Proposed Temporary Logistics Centre for a Period of 3 Years & Filling of Land at Lot 403 RP (Part) in D.D. 103 and Adjoining Government Land, Kam Tin, Yuen Long, New Territories

The response to comments of CE/MN, DSD and Director of Fire Services (D of FS) are attached herewith.

Response to DSD's comments - Proposed Temporary Logistics Centre for a Period of 3 Years and Filling of Land in "Agriculture" Zone, Lot 403 RP (Part) in D.D. 103 and Adjoining Government Land, Kam Tin, Yuen Long, New Territories (Application No. A/YL-KTS/993)

Figure 4

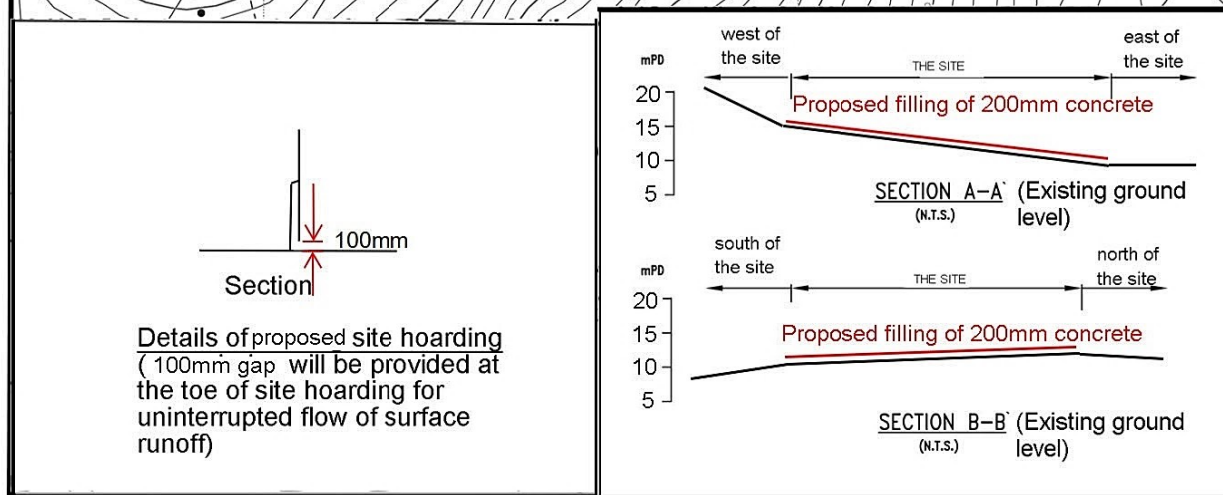
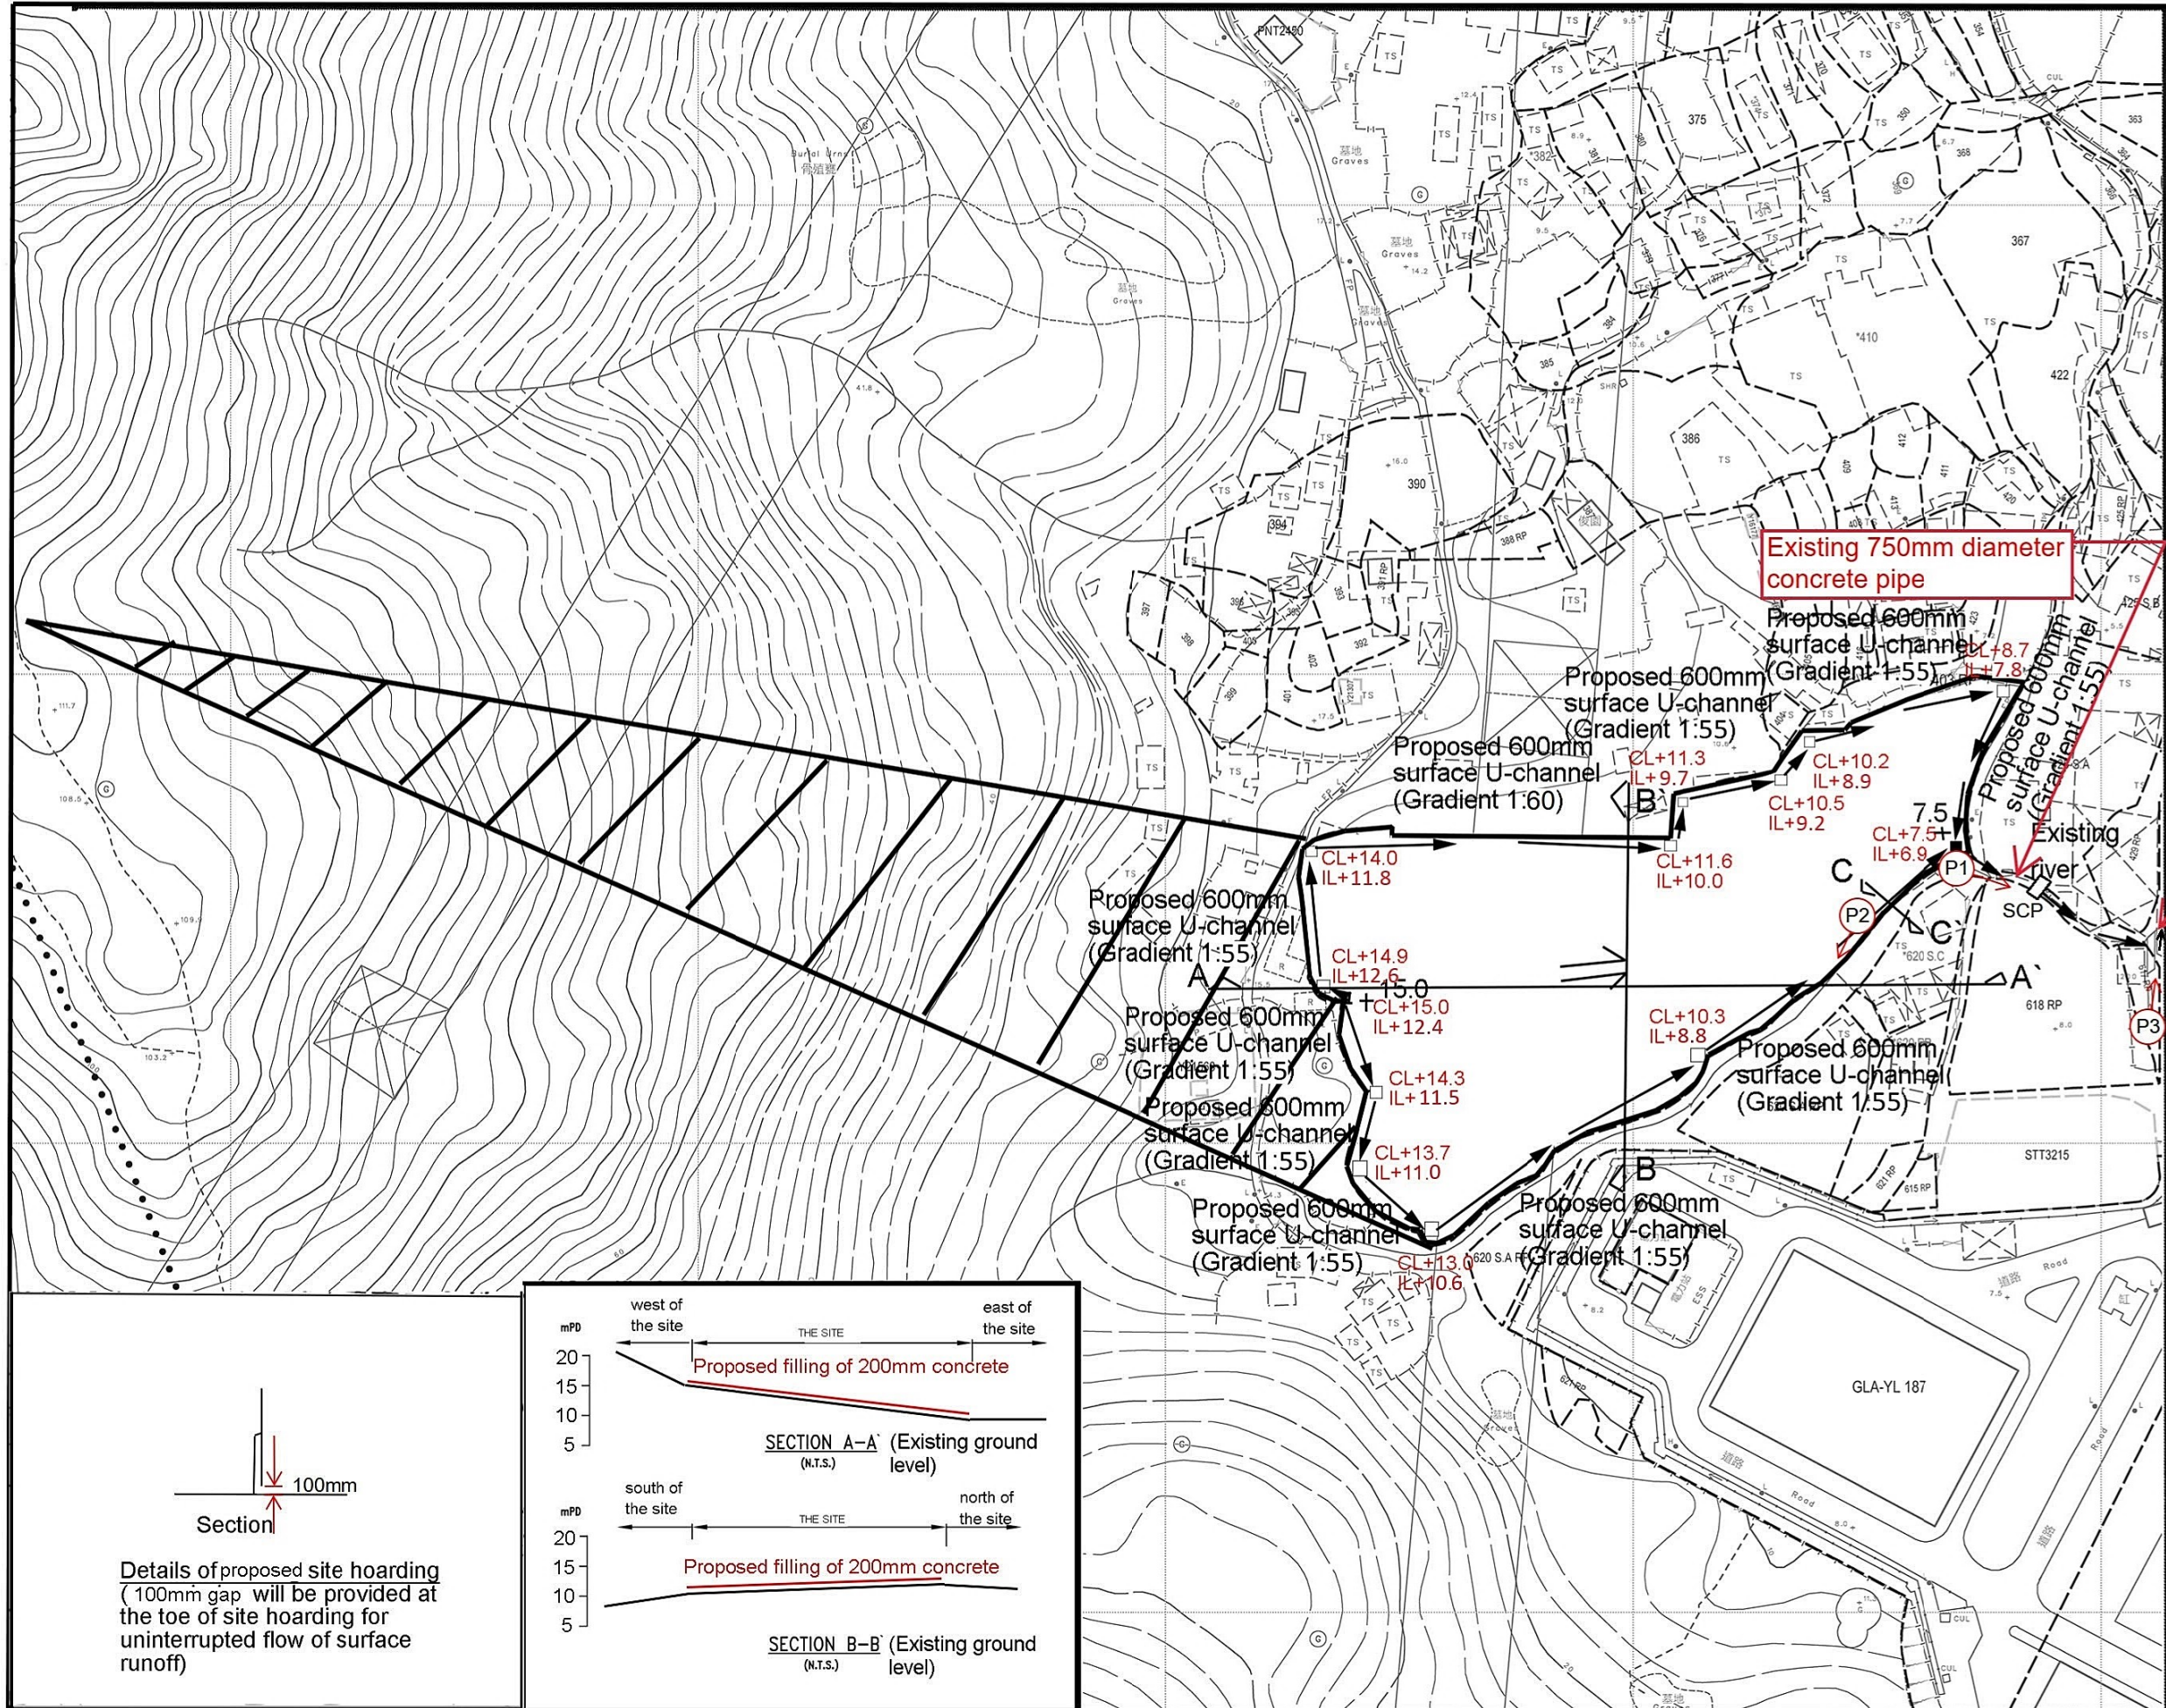
(a) Please indicate the existing opening drain and the discharge path on photo 1 & 2. Please also indicate the photo taken directions on drawing.	please see the updated Figure 4.

(b) Please show the size of the existing drainage facilities, i.e. the aforementioned existing opening drain and the discharge path, on drawings.	please see the updated Figure 4.

Figure 5 - Catchpit (SCP)

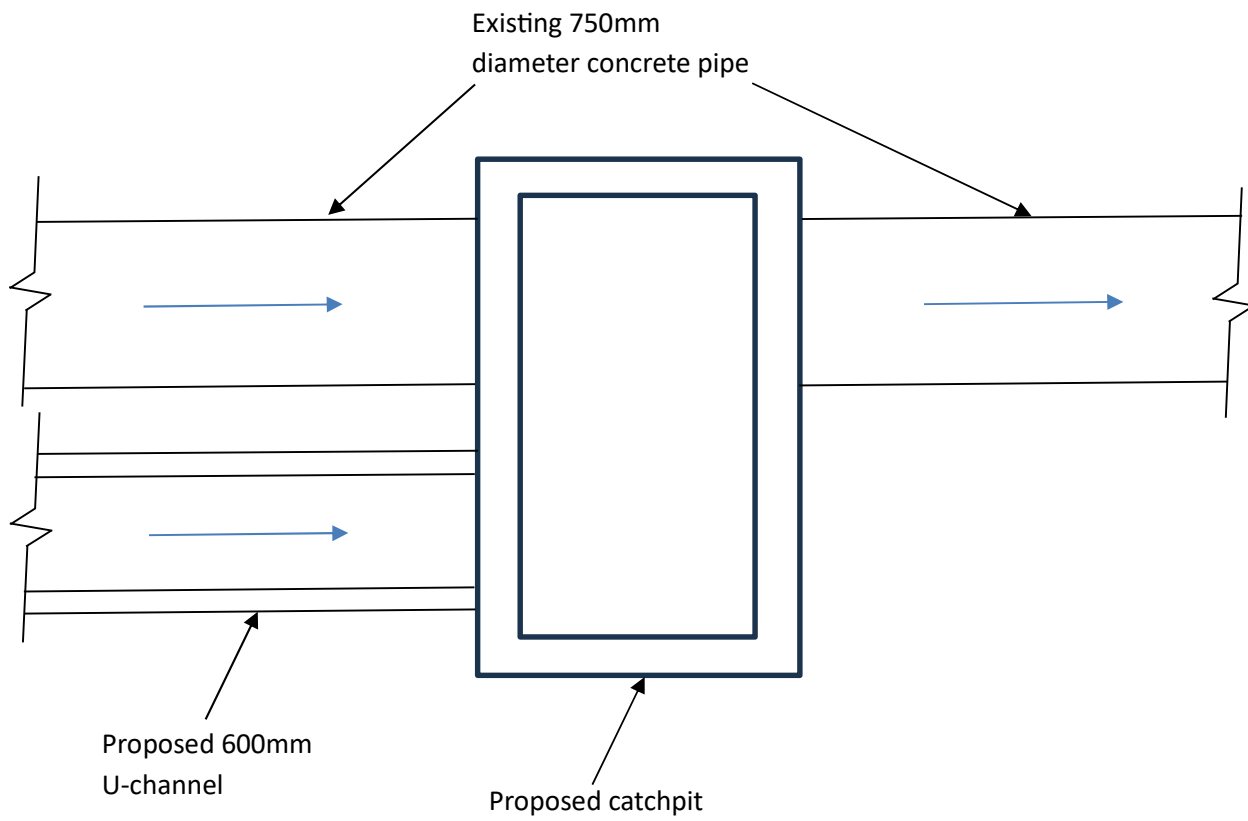
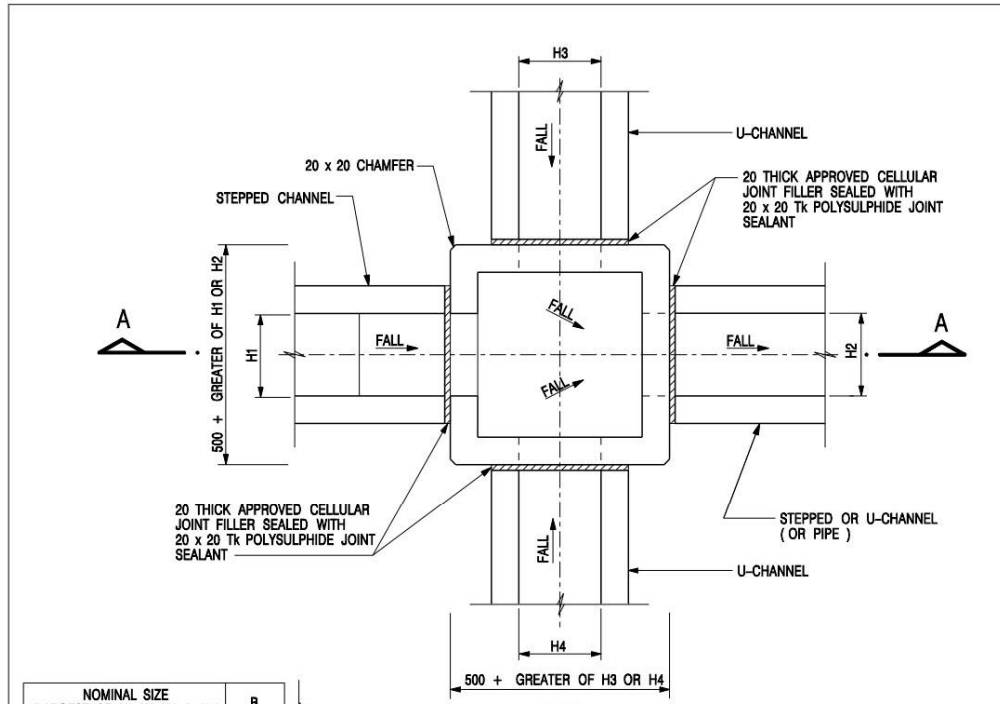
(c) Connection details of the proposed channel at the proposed channel at the proposed discharge point at river should be given.	please see the enclosed Figure 5.

Figure 8.7 - Chart for the Rapid Design of Channels

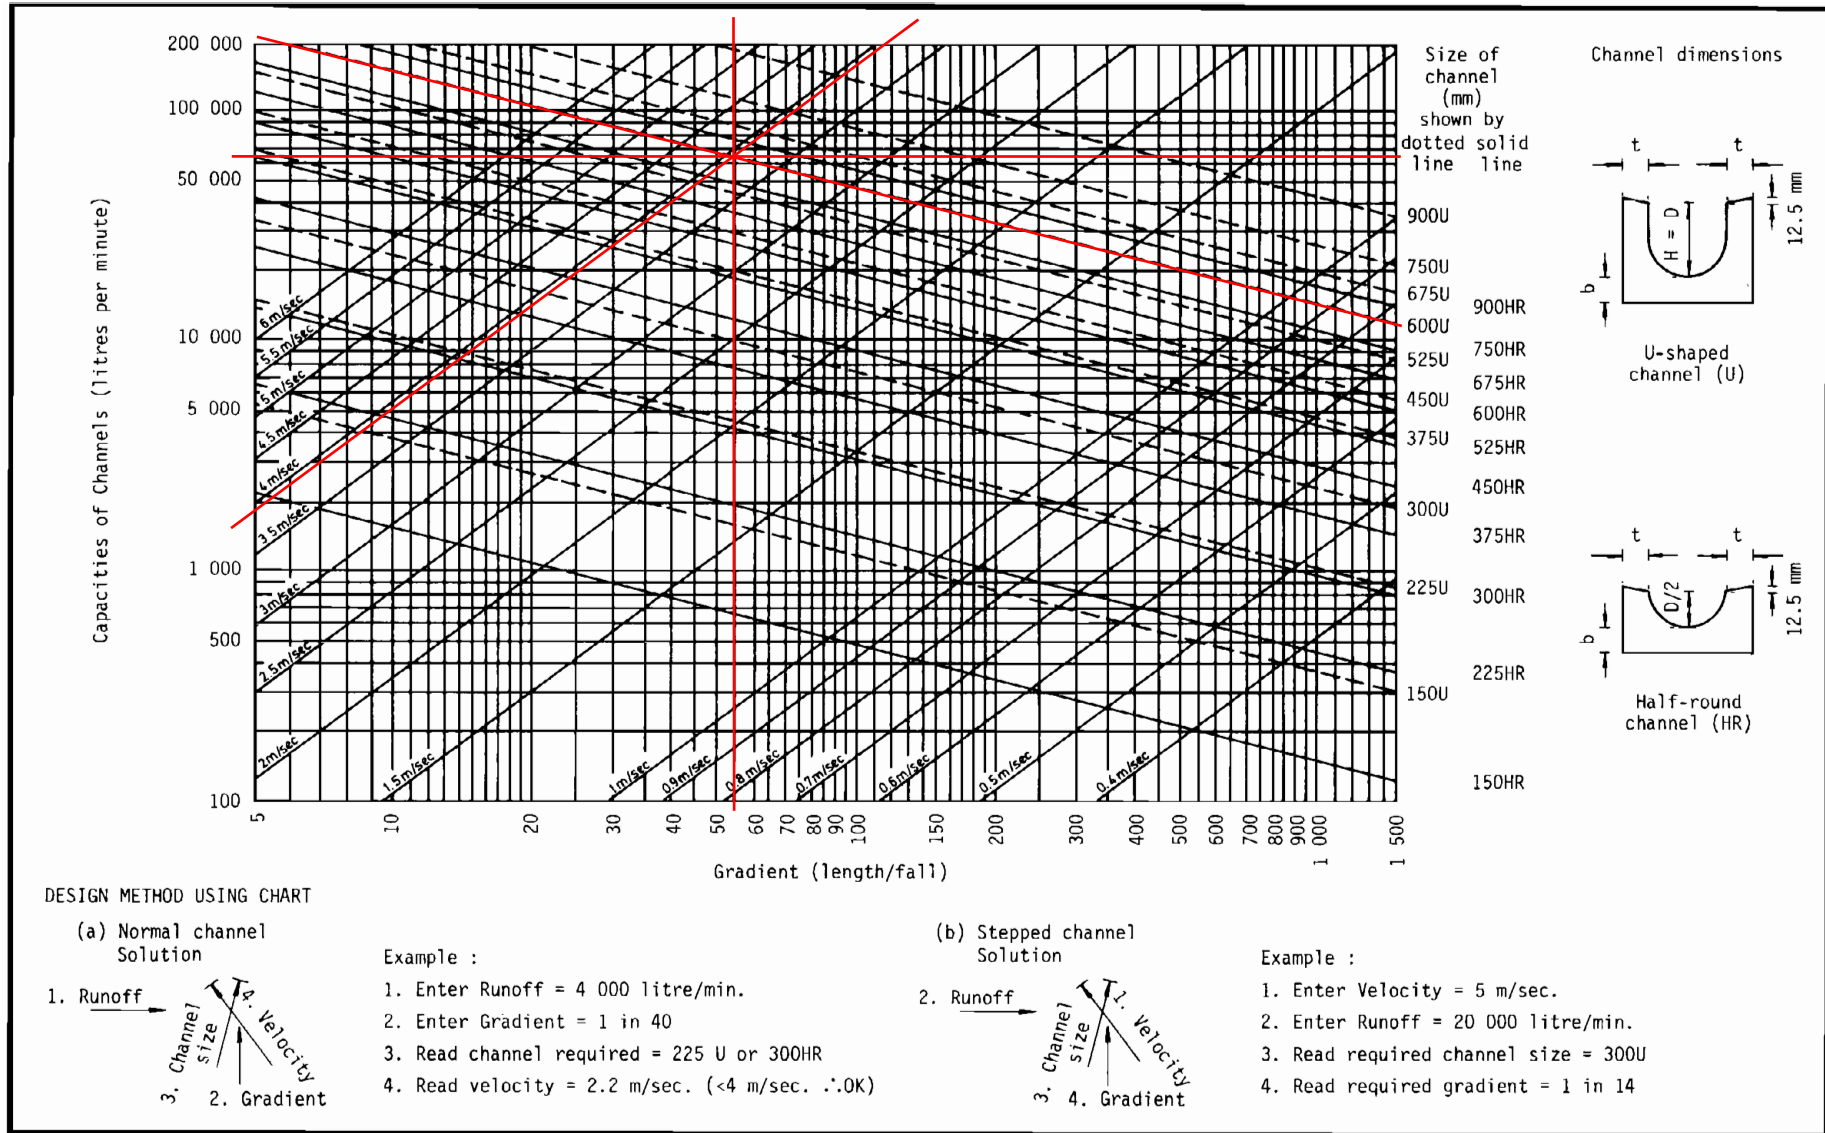
(e) The velocities of stormwater flow in channels should be checked and given in the submission.	please see the enclosed design chart which shown the revised gradient is 1 : 55 and the velocites of stormwater flow in channel is around 3.9m/s.
Please specify the distance between the proposed gaps and the height of the 100mm gaps in figure 4.	please see the updated Figure 4.
